ADDENDUM NO. 1
July 10, 2023

Project: **2023 145 Canyon Road Restabilization Project (51-813)**
Town of Fairfax and Miller Pacific
Engineering Group

ADDENDUM NUMBER 1

1. Sheet 2 (Site Plans – Existing & Proposed), Sheet 3 (Wall Profile & Details) and Sheet 4 (Tieback & Waler Details) have been revised as part of the response to Bidders’ questions and the updated sheets are included herein.
2. Sheet L-1.0 (Demolition Plan) has been added to show the extents of vegetation and tree removal.
3. Sheet L-3.0 (Revegetation Details) has been added to show details for new plantings.
4. Copy of Streambed Alteration Agreement (EPIMS-MAN 27091-R3) between Town of Fairfax and California Department of Fish and Wildlife now added. Conditions contained within permit must be included in Bid Cost and Scope of Work to be performed.

WALL PROFILE & DETAILS

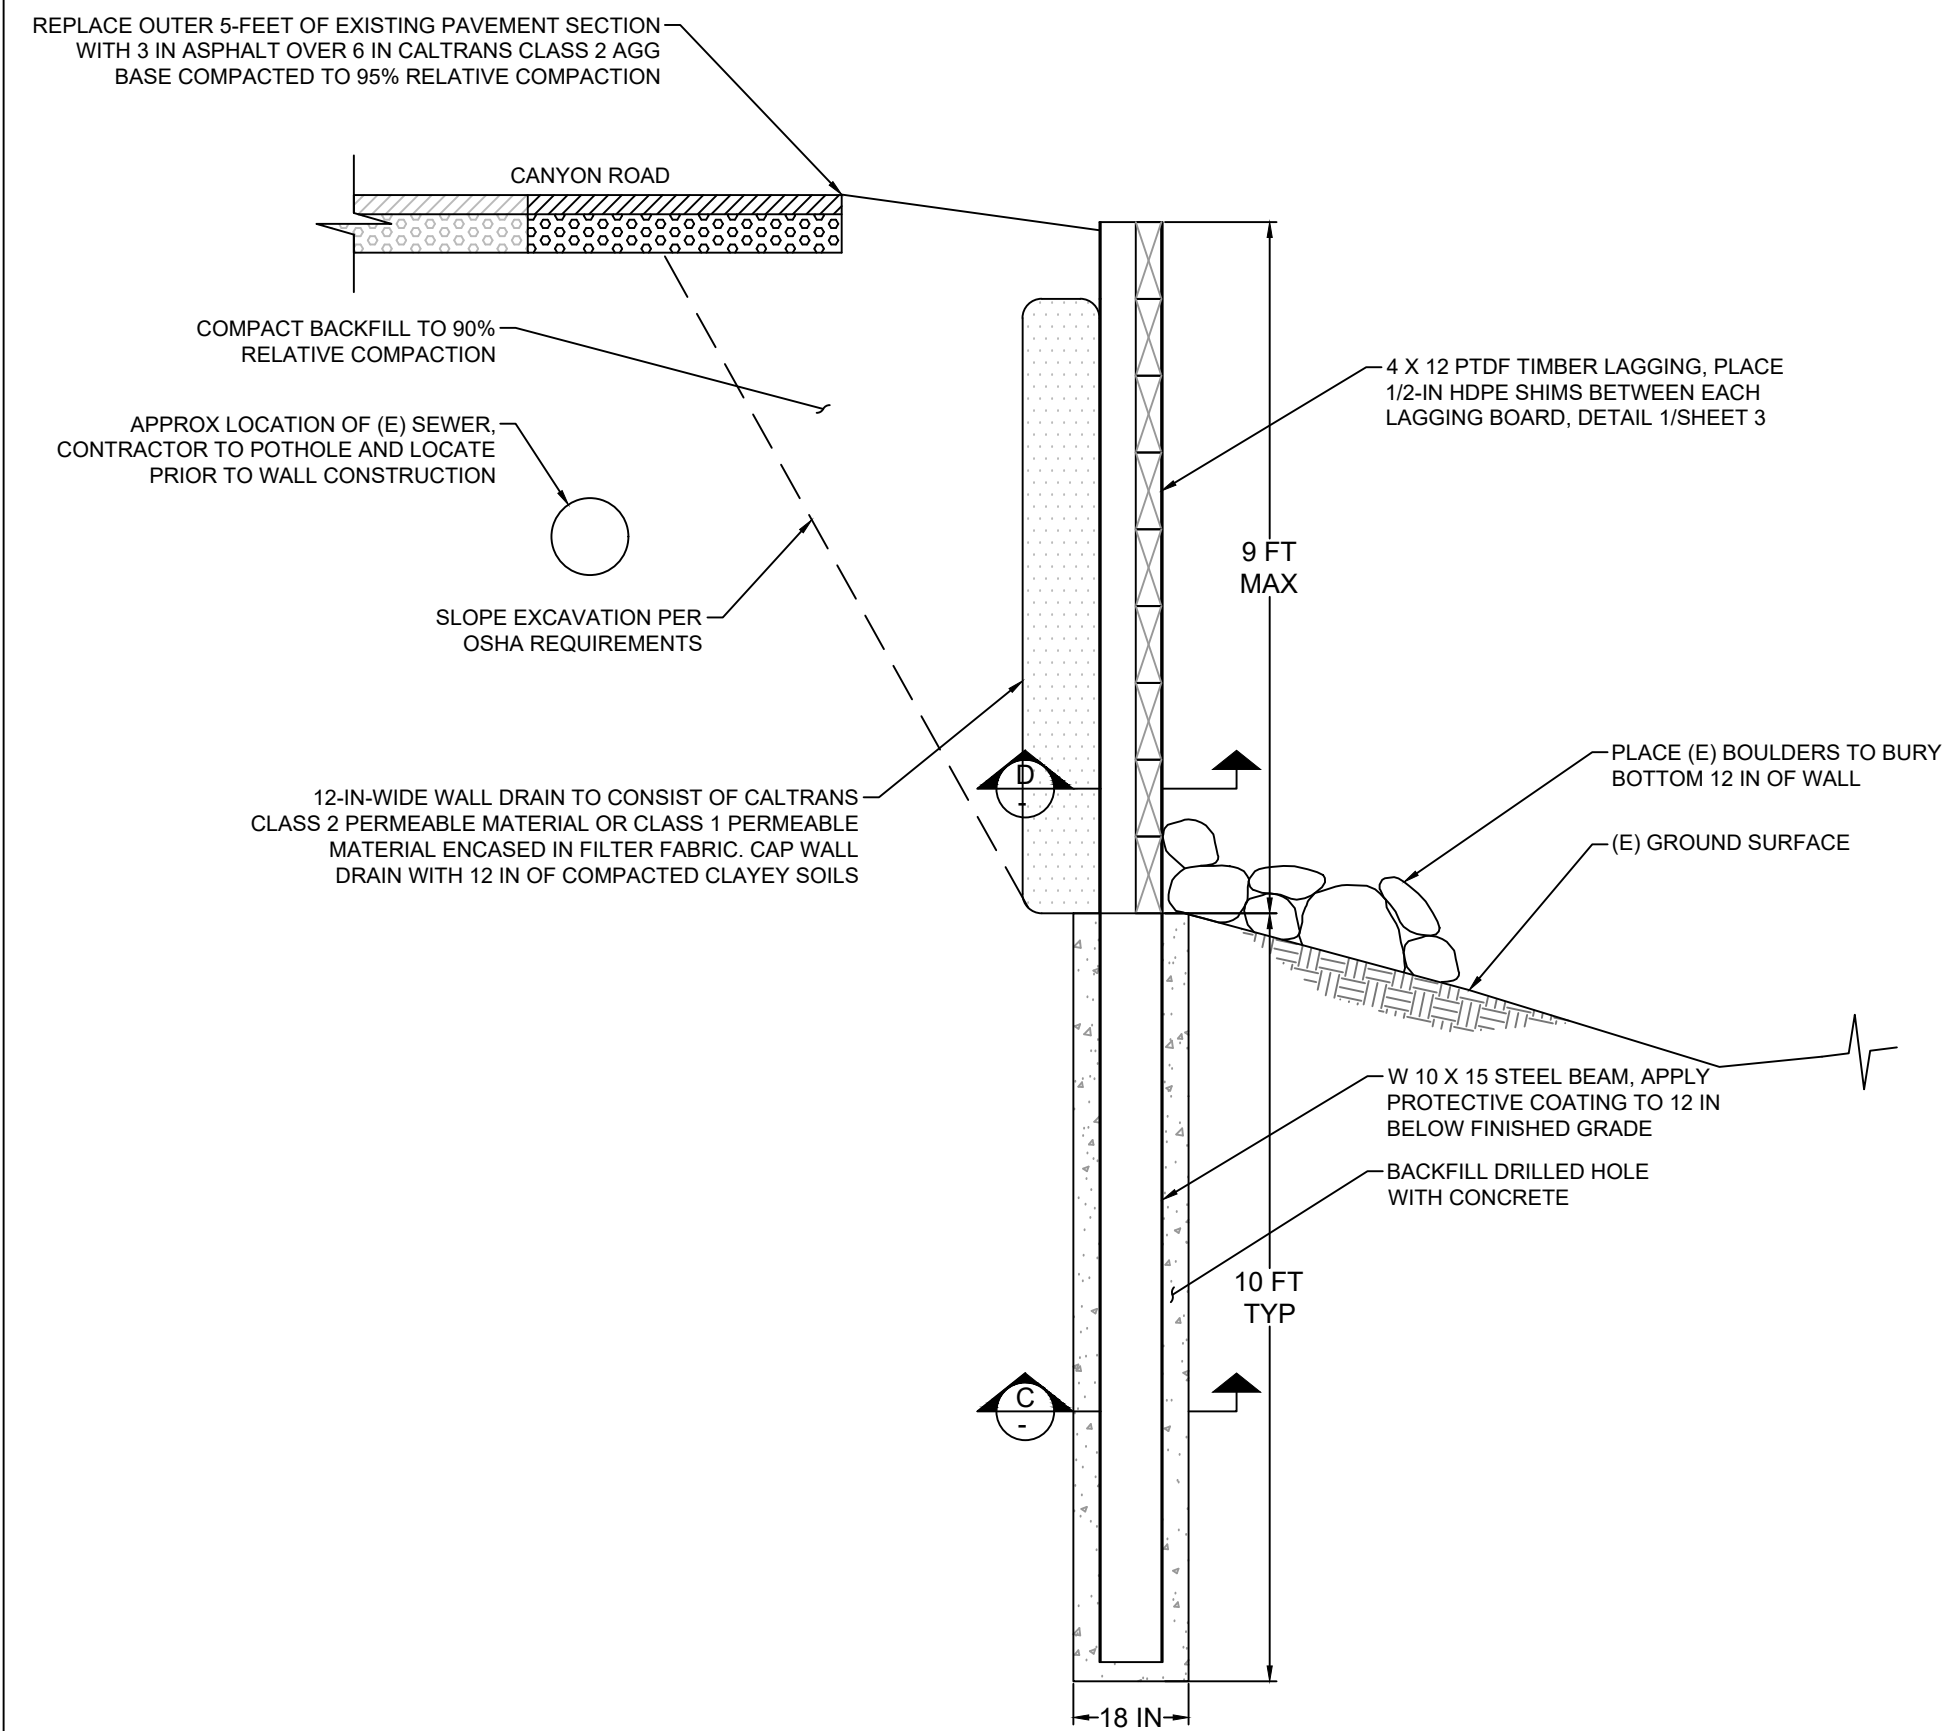
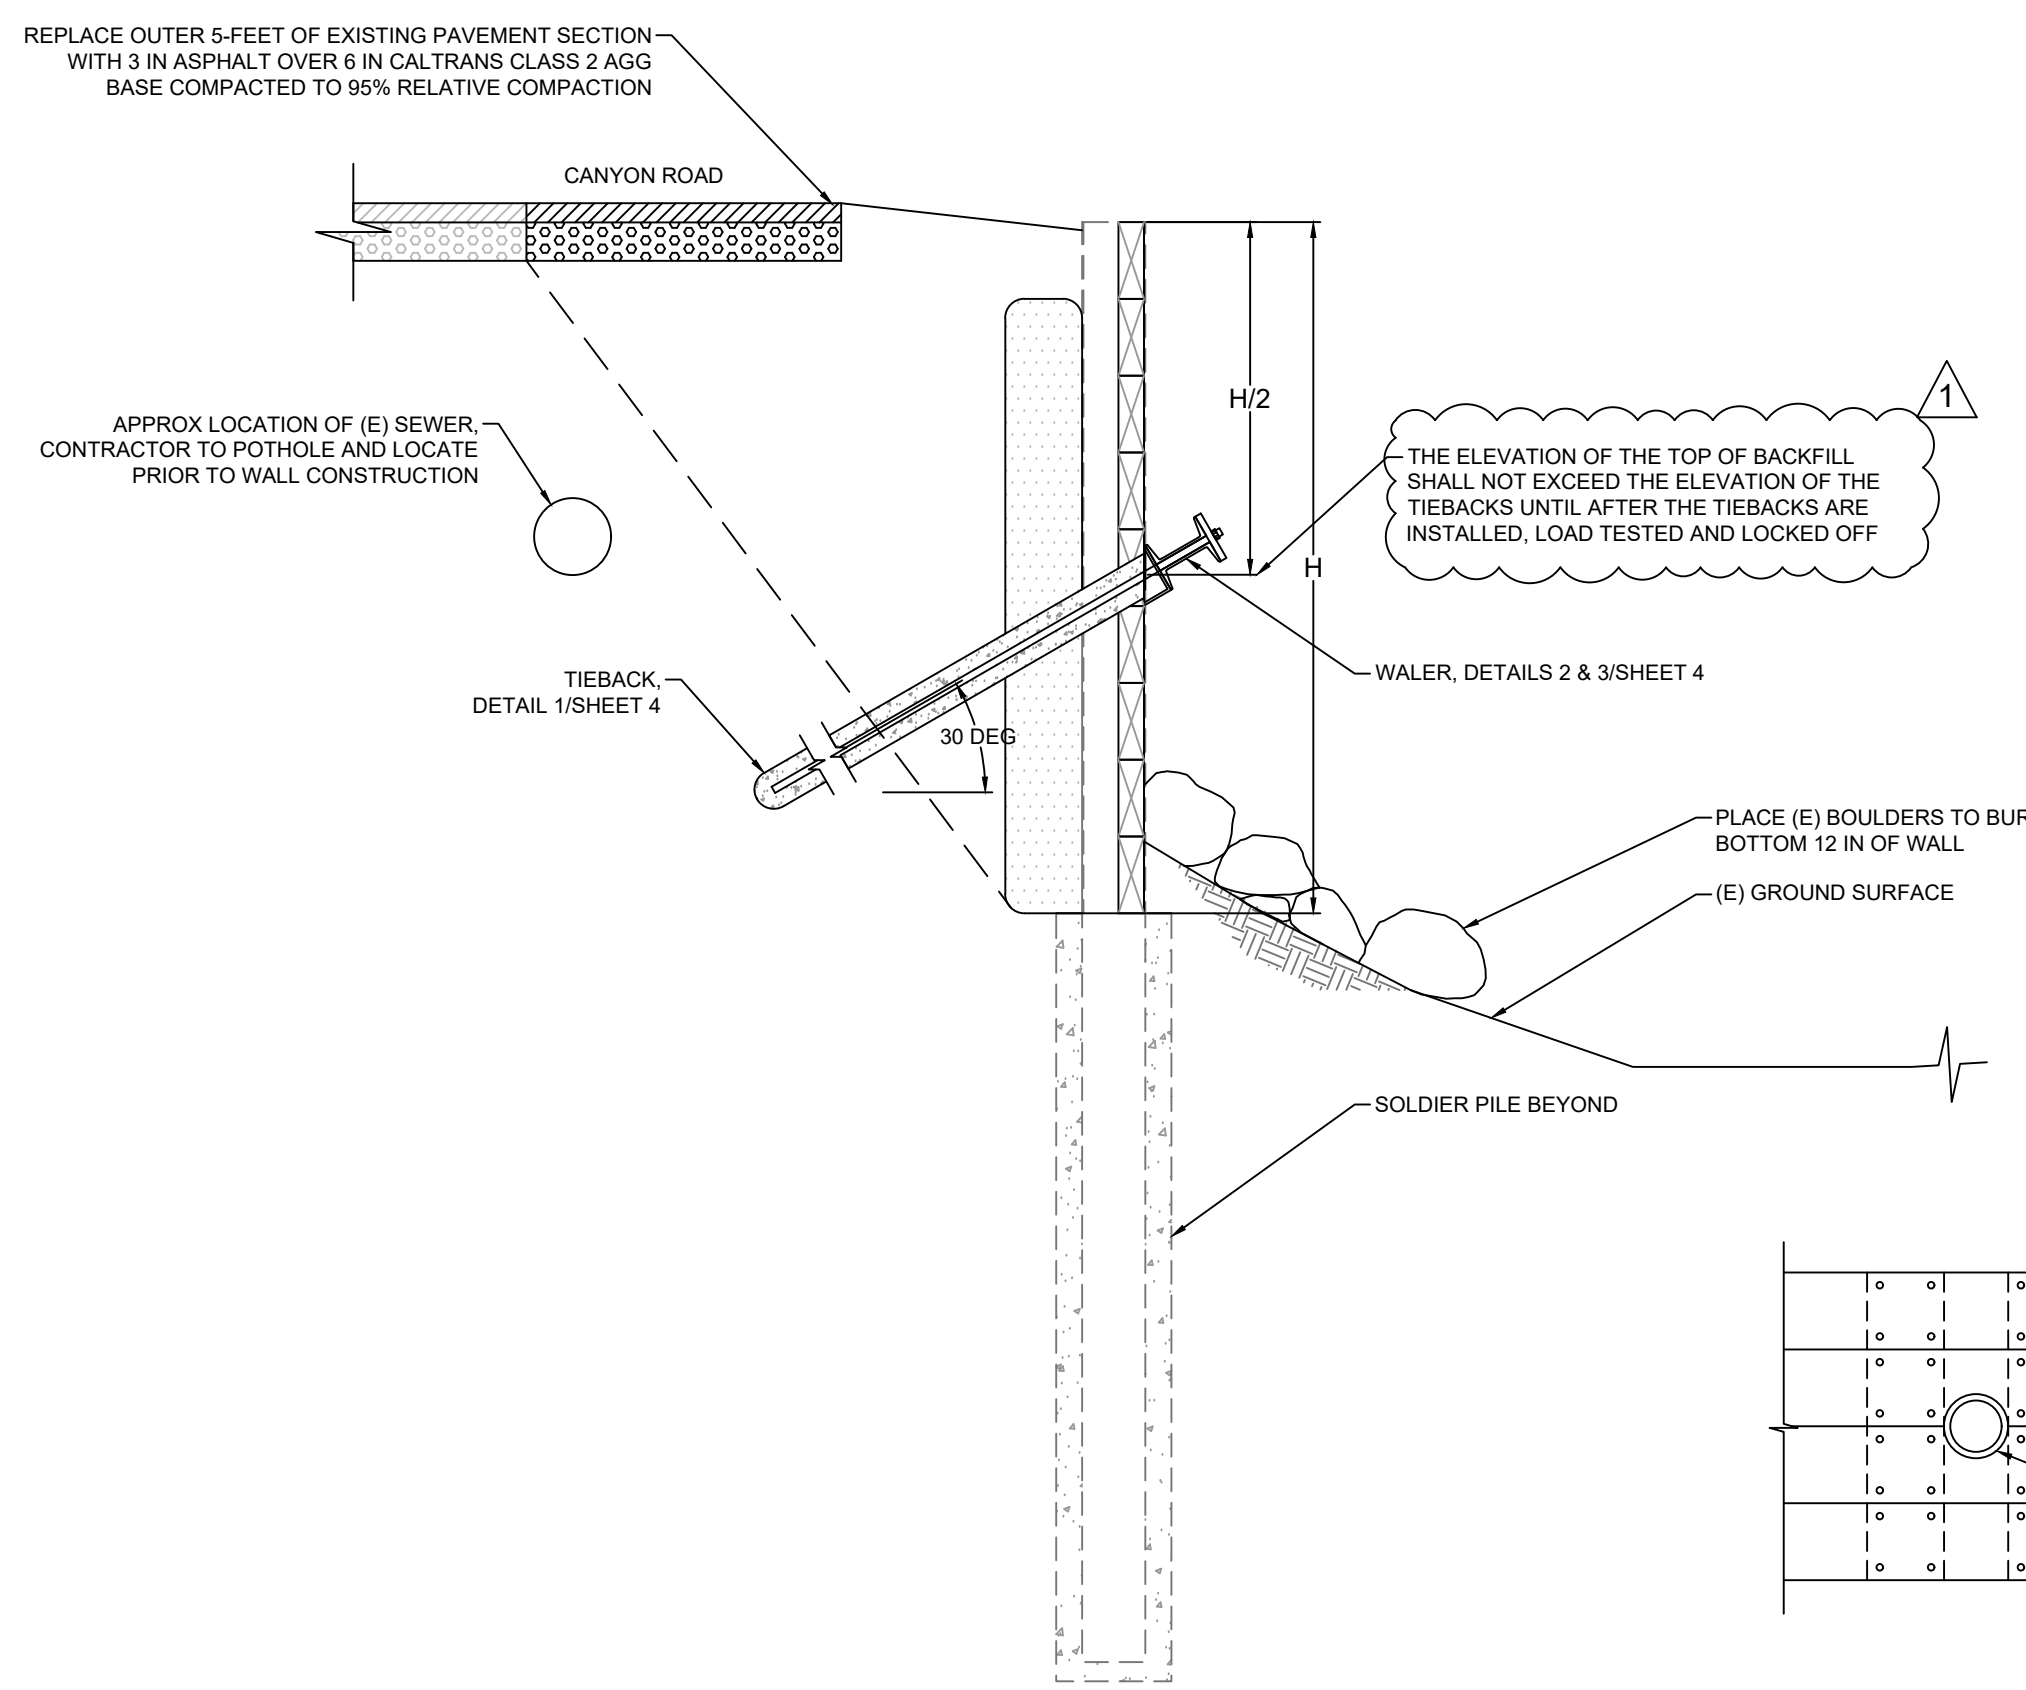
8. Can the wall be backfilled prior to tieback installation?

Backfill should not be placed above the tieback elevation until after tiebacks are installed, load tested and locked off.

TIEBACK & WALER DETAILS

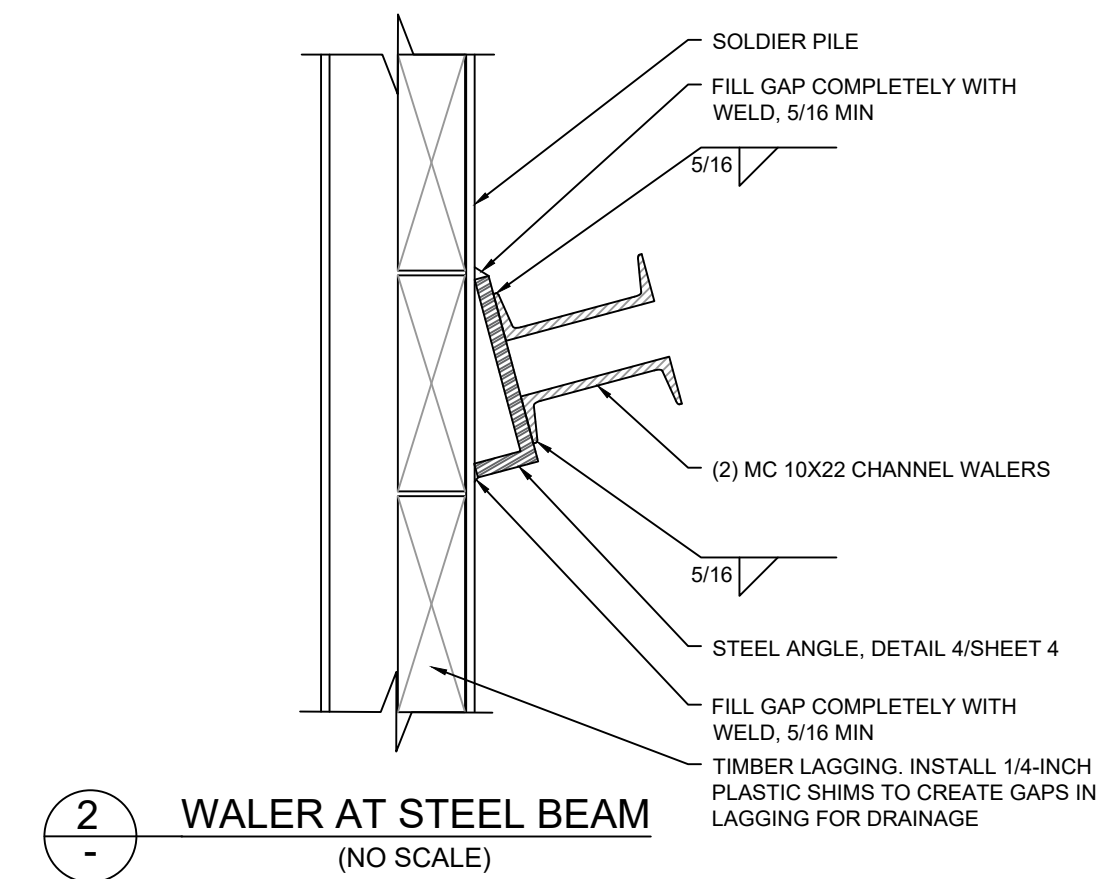
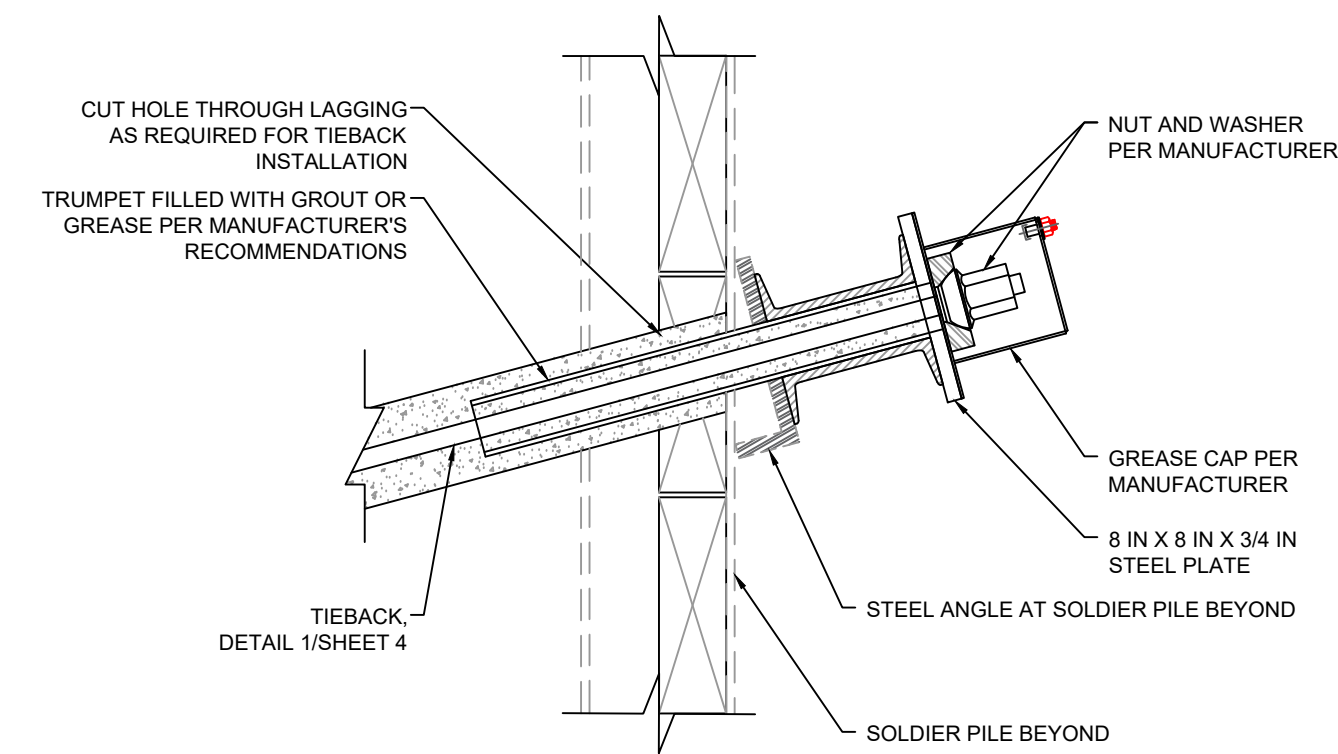
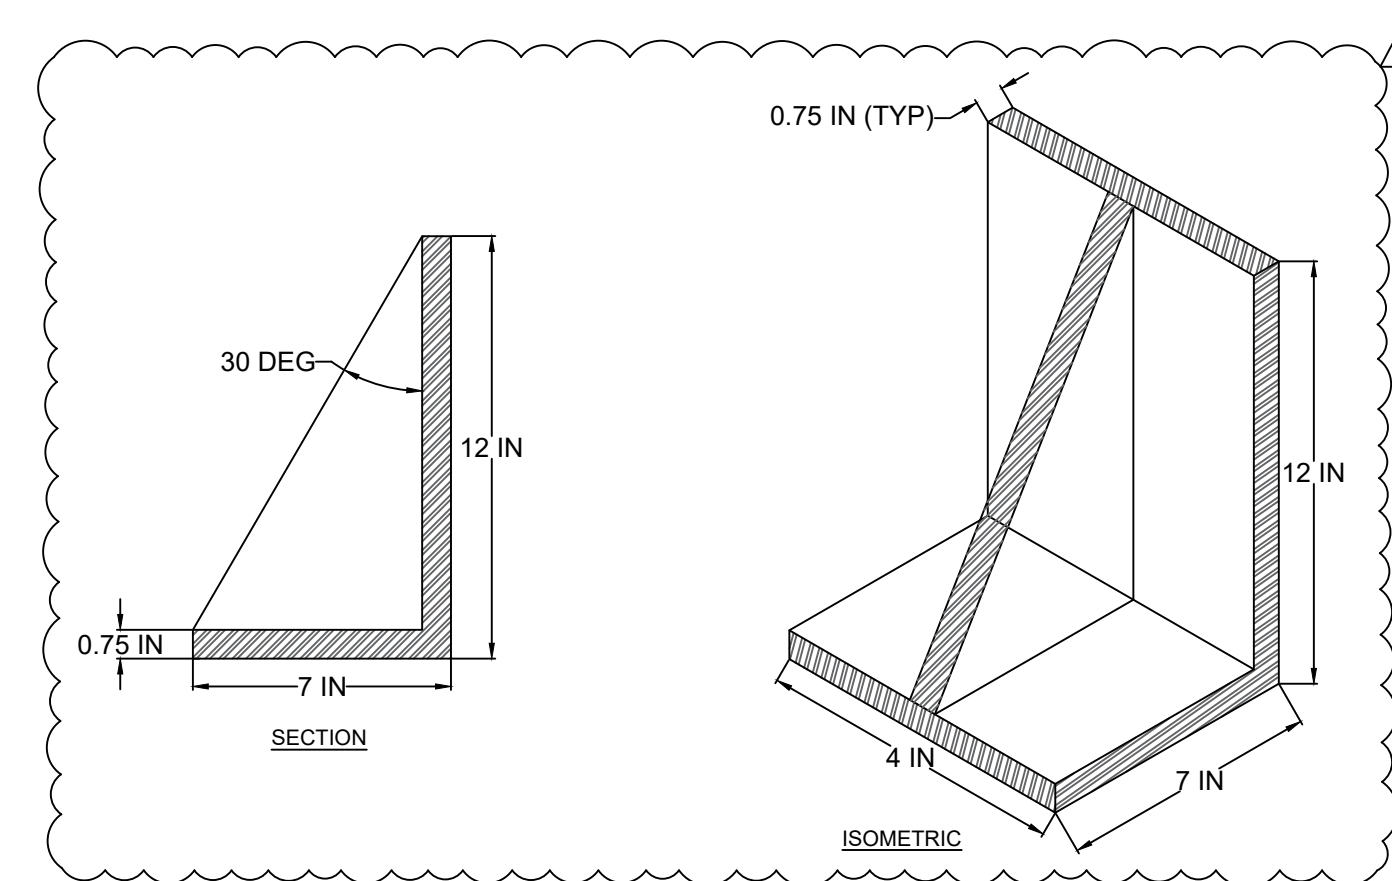
4. Please provide detail for waler splices.

5. Please provide information on intended waler installation process.

6. Tieback #11 may have a vertical batter of up to 45-degrees. How is waler to be installed here?

7. What diameter hole in waler steel plate at tieback location?

The waler design assumes a simply-supported condition with max span length of 6-feet. It can be installed as a series of 6-foot long segments in between each pile.

Because the moment/structural demand for a continuous waler is less than for the simply-supported condition, the Contractor may utilize a continuous waler if desired. If a continuous waler is utilized, the waler may be terminated with the end centered on and welded to the steel angle/soldier pile, and no splice with adjacent waler segments is required.

Anticipated construction sequence would include (1) install soldier piles and lagging, (2) backfill to tieback elevation, (3) install tiebacks, (4) install waler, (5) load test and lock off tiebacks, then (6) backfill to top of wall. Refer to response to question #4 regarding splicing.

If steepening of the tieback is required, beveled washers could be installed between the tieback bearing plate and nut and/or shims can be placed between the waler and steel angle to facilitate the steeper inclination. Note that Detail 4 on Sheet 4 has been modified to provide a larger steel angle to provide for more contact area between the waler and steel angle to accommodate adjusting the positioning of the waler if needed.

Waler plate holes should be 1-1/4-inch diameter.
